SECTION 009113 – ADDENDUM ONE

- A. Project Name: 22034.02 Meridian High School Additions, Renovations and Ballfield Rebid
- B. Owner: Meridian Public School District, 1019 25th Avenue, Meridian, MS 38391
- C. Architect: Dale | Bailey, an Association, One Jackson Place, Suite 250, 188 East Capitol Street, Jackson, MS 39201-2100
- D. Architect Project Number: 22034.02
- E. Date of Addendum One: 5 January 2024

1.4 REVISIONS TO DRAWINGS

C-302

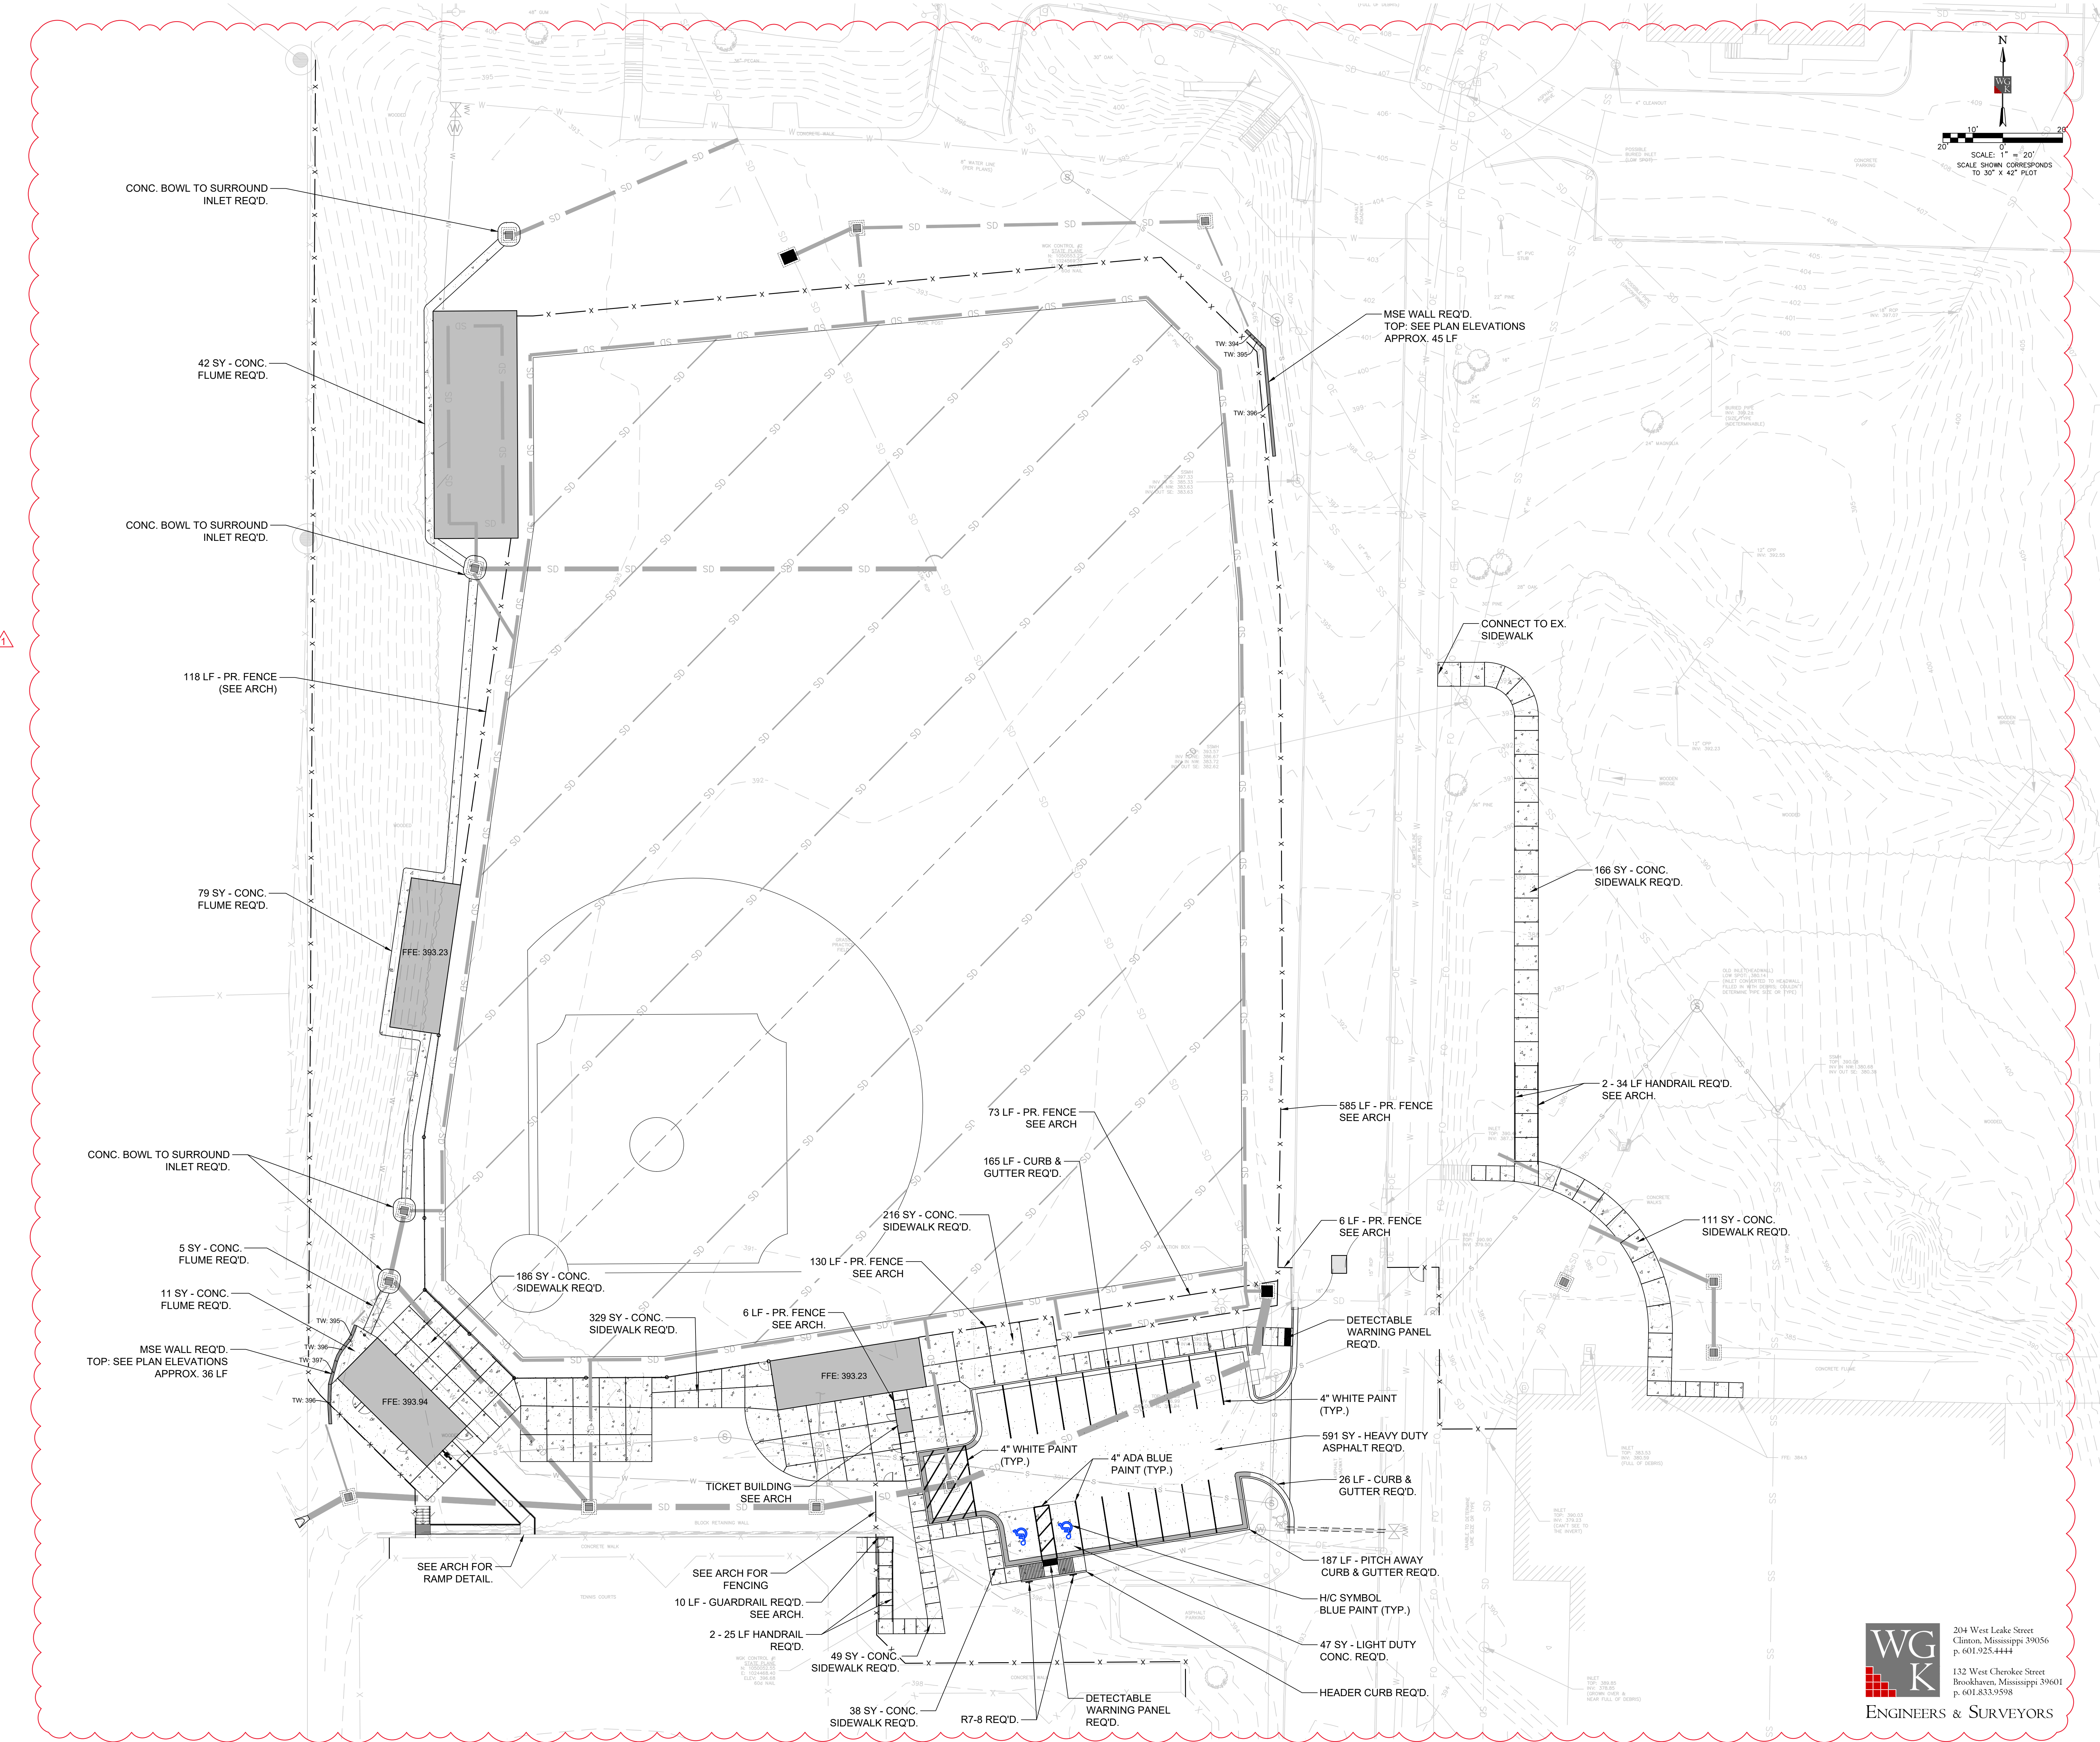
- J. Sheet C-302 (New). Added sheet to reflect site items of work at baseball area
- K. Sheet C-400 (Revised). Updated to reflect additional dimensions at baseball area

C-402

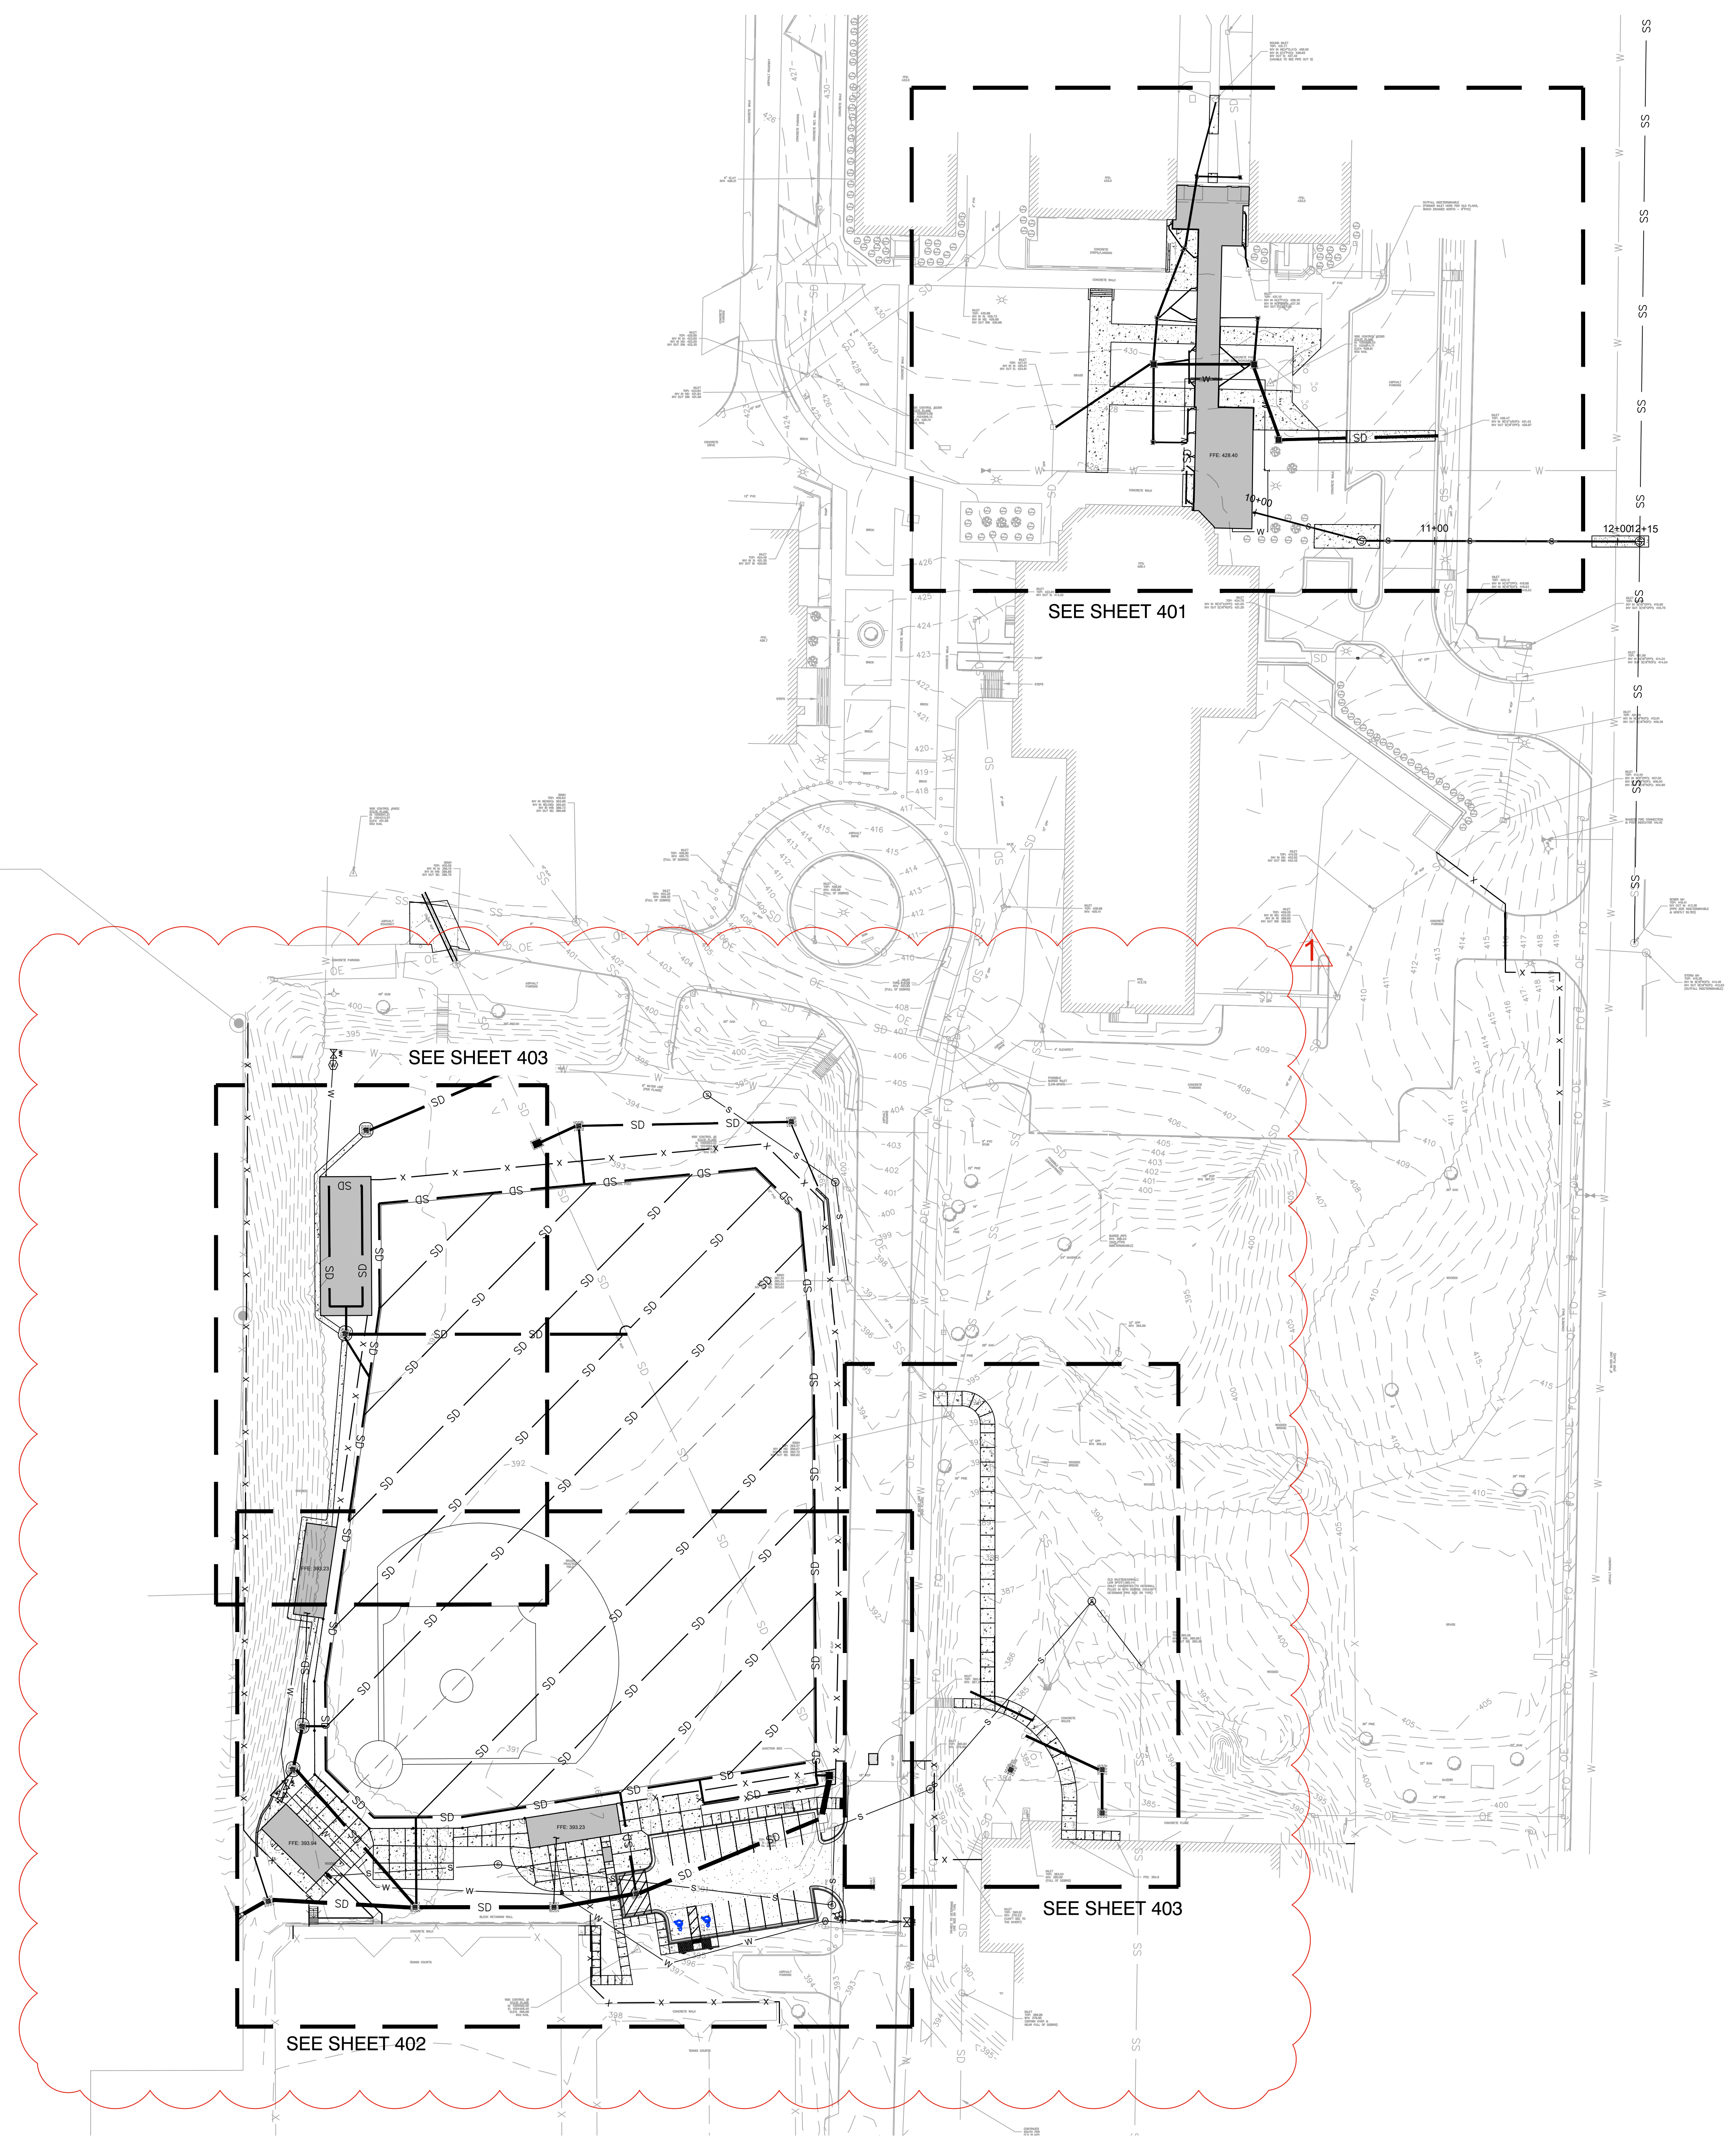
- L. Sheet C-402 (New). Added to reflect dimensions/layout of work at baseball area
- M. Sheet C-403 (New). Added to reflect dimensions/layout of work at baseball area
